## **ADDENDUM NO. 01**

September 16, 2016

### **Project: POV Parking Lot – Centralia Readiness Center Washington Military Department, State Project #2016-628**

**PIPE ZONE BEDDING AND BACKFILL**  
**STANDARD PLAN B-55.20-00**

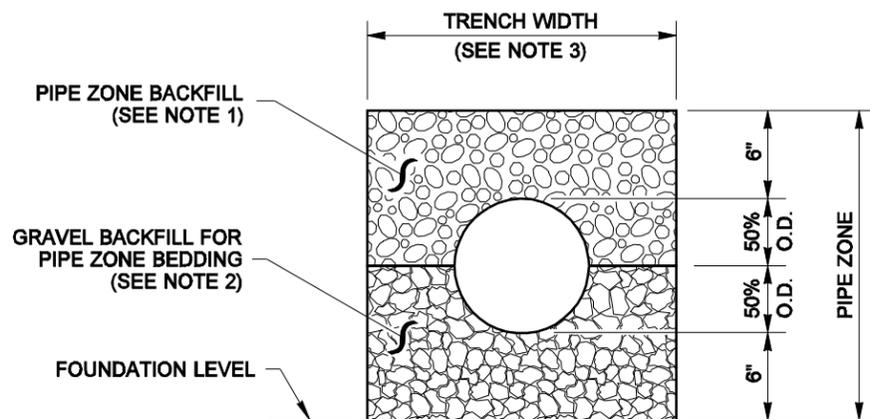
Item #G05      Pipe Zone Bedding and Backfill

ADD #01      Provide pipe zone bedding and backfill per WSDOT standard plan B-55.20-00 for thermoplastic pipe.

### GATE NOTES AND DETAILS

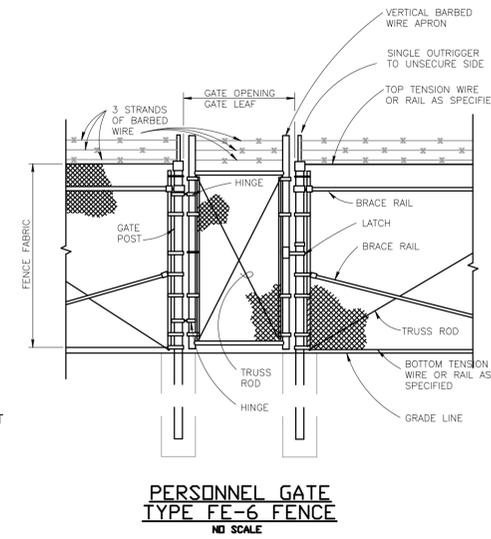
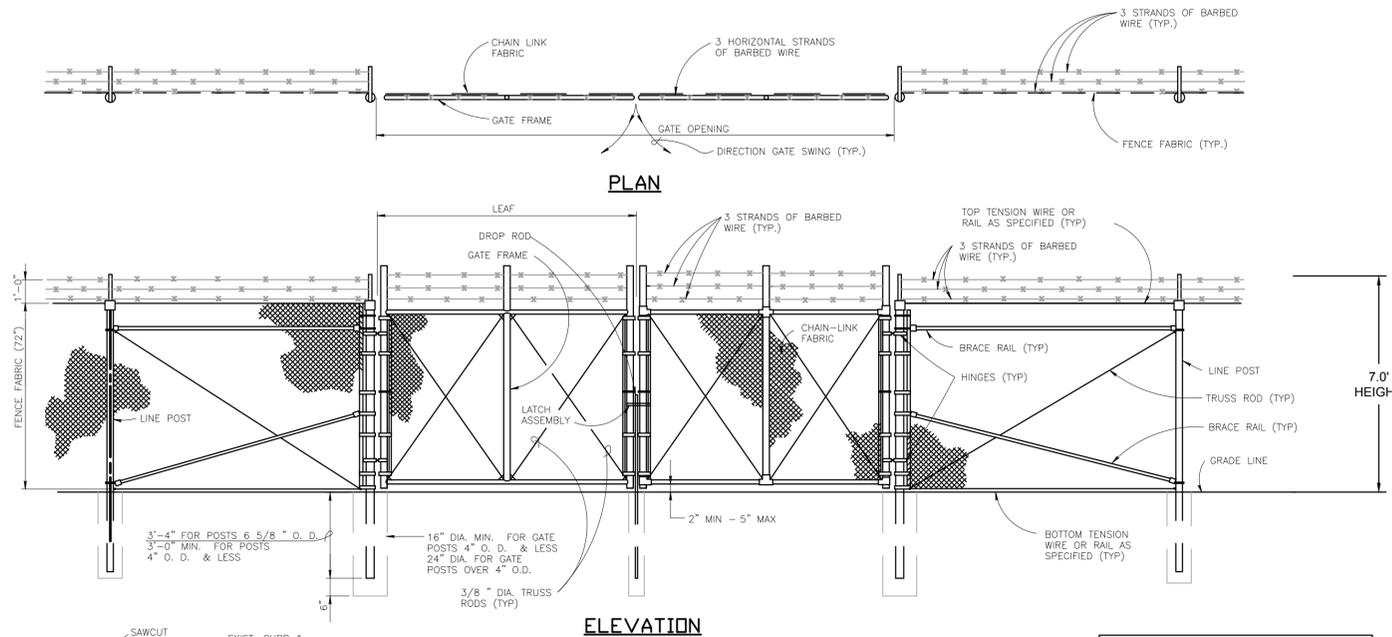
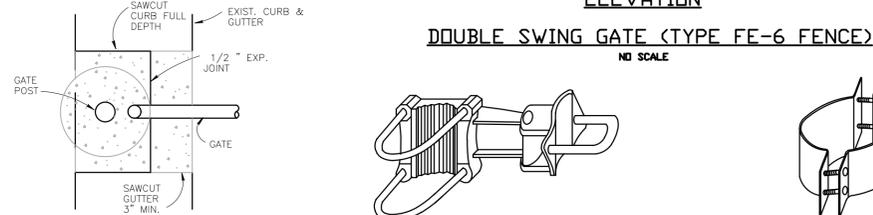
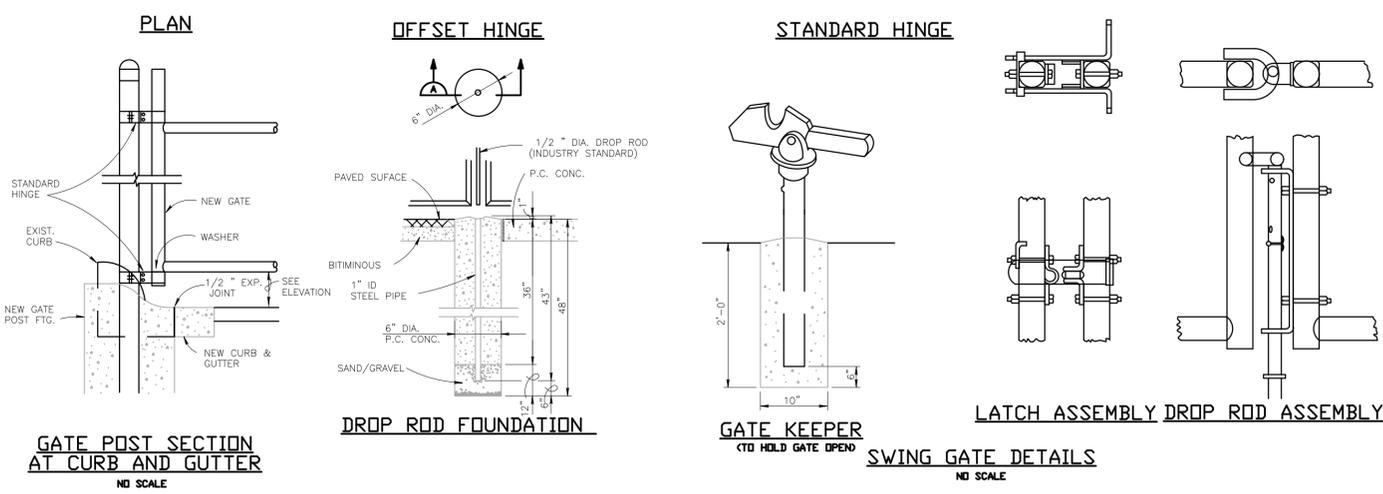
Item #C01      Permanent Fencing –

ADD #01      Replace Sheet C-304: GATE NOTES AND DETAILS

The site security fencing is approximately 6.0' tall (72" Fabric width) plus a 3 strand barb wire on an extension arm. Refer to revised sheets C-304 and C-305.

Sheet Title:  
**FENCE NOTES AND  
DETAILS**

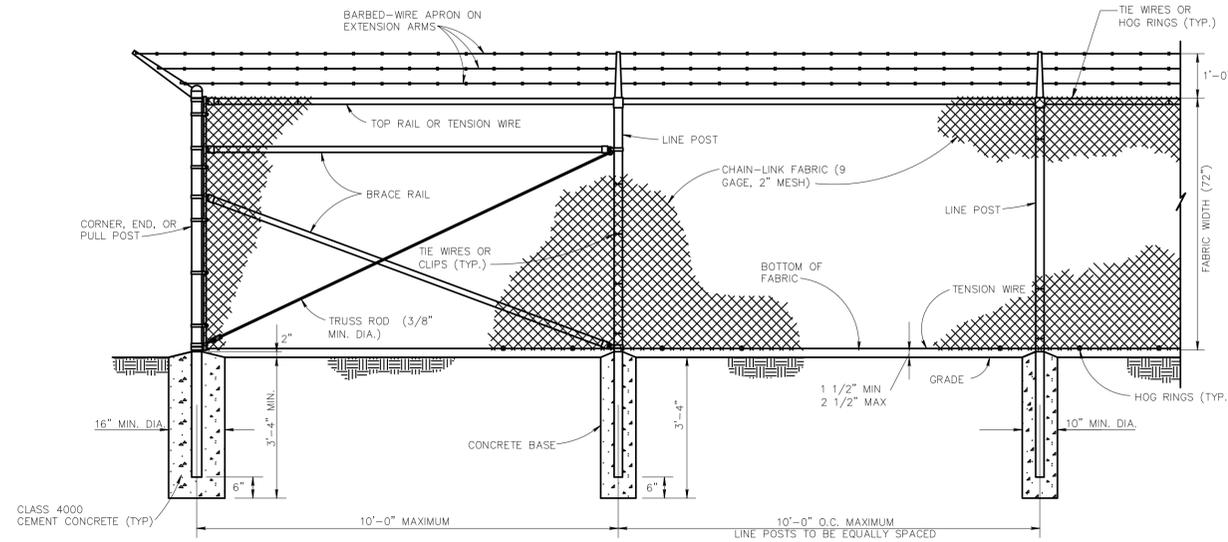
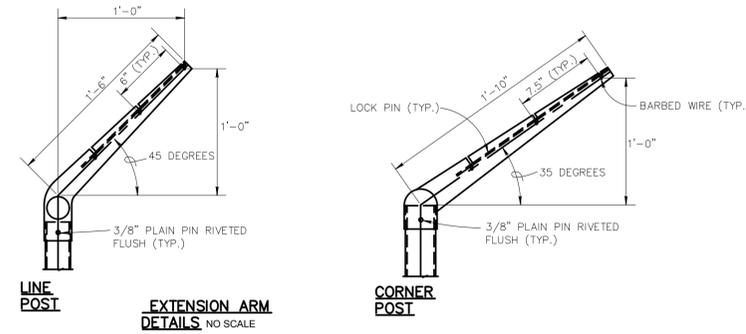
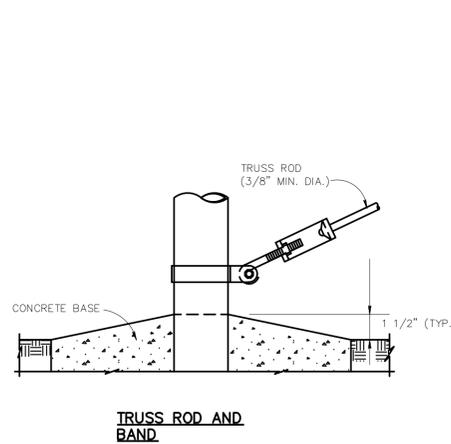
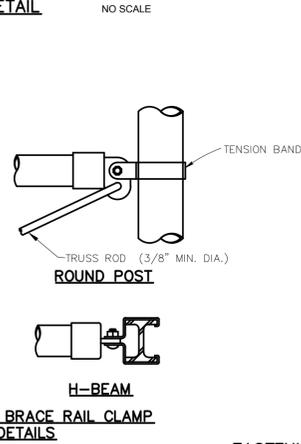
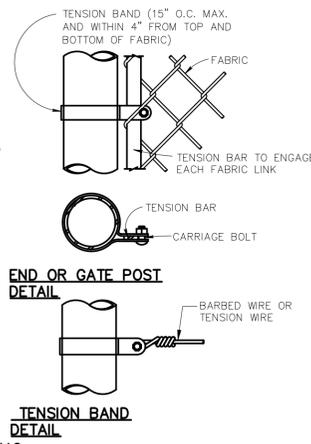
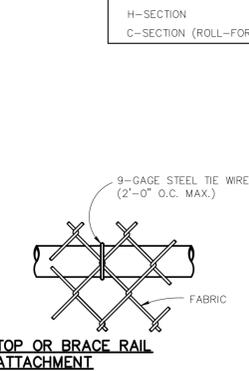
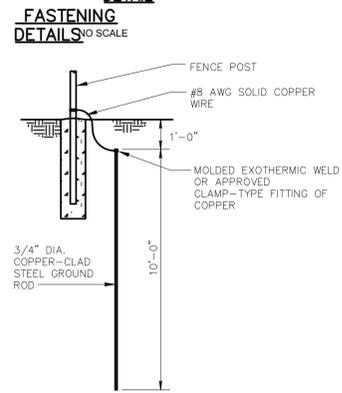
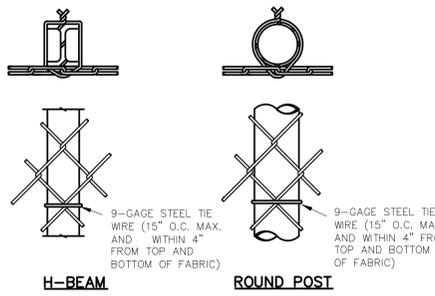
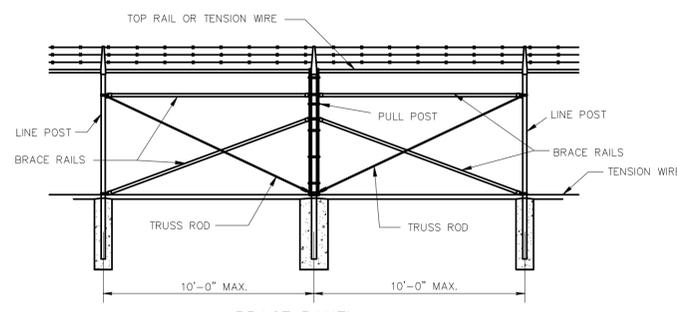
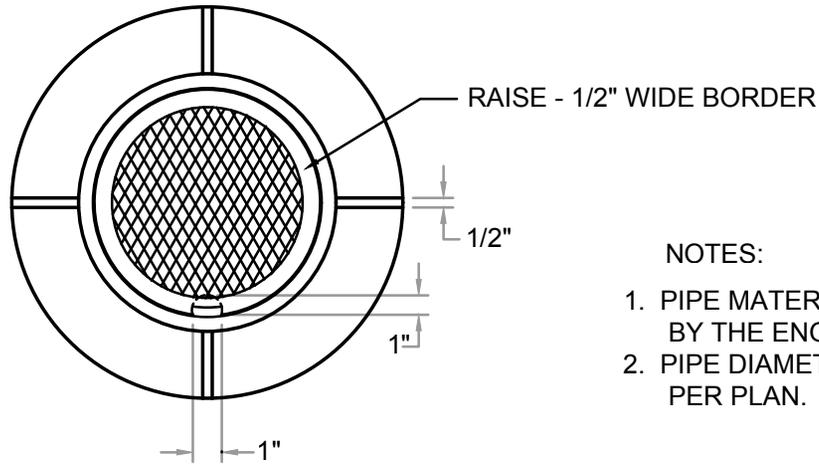
Replace Sheet C-305: FENCE NOTES AND DETAILS

**CAST IRON RING AND COVER**

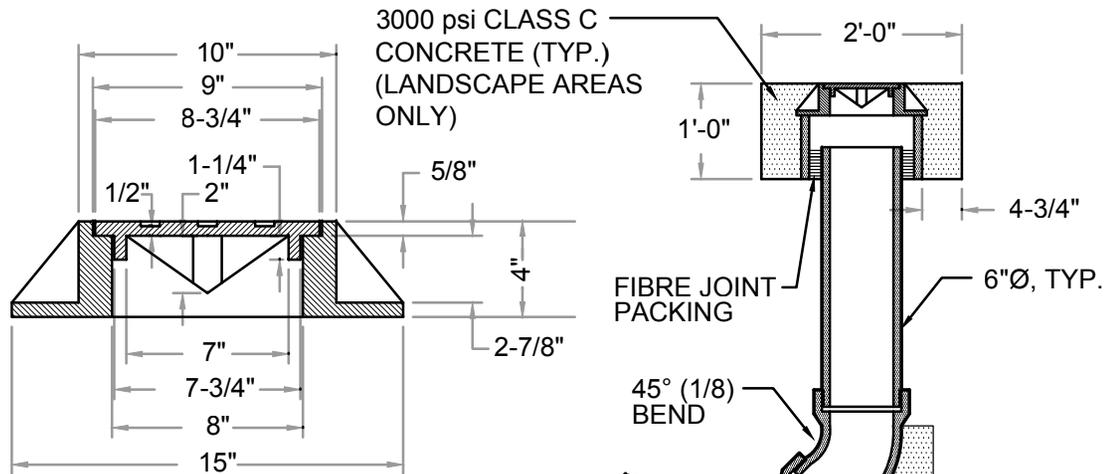
Item #C02      Storm Cleanouts

ADD #01      Reference sheet C3.01

ADD a storm cleanout at the end of each 6" Perf. Pipe located within the bio-retention swales for maintenance. Storm Cleanout Detail included.
